**INTERPRETATION IC 15-2022-2 OF
ANSI/ASHRAE STANDARD 15-2022
SAFETY STANDARD FOR REFRIGERATION SYSTEMS**

Date Approved: July 28, 2023

Reference: This request for interpretation refers to the requirements presented in ANSI/ASHRAE Standard 15-2022, Section 7.6.1, regarding Equations 7-8 and 7-9.

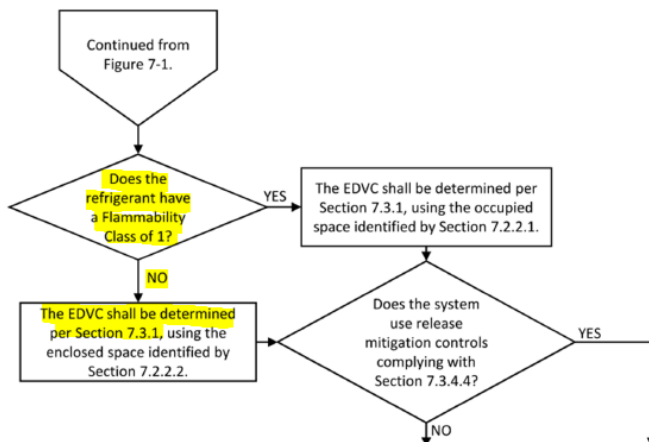
Background: As currently written, Section 7.3 states that “All refrigeration systems shall follow the compliance path in Figure 7-1 and Figure 7-2” and Figure 7-2 states that if the refrigerant is of a Flammability Class other than 1 (which would include 2L), then the “EDVC shall be calculated per Section 7.3.1.”

Interpretation No.2: The highlighted text in Figure 7-2 (see above) reads “The EDVC shall be calculated per Section 7.3.1...” But if an A2L refrigerant is used in a high-probability system for human comfort, the EDVC shall be calculated per Section 7.6.1, and Section 7.3.1 does not apply.

Question No.2: Is this Interpretation correct?

Answer No.2: Yes
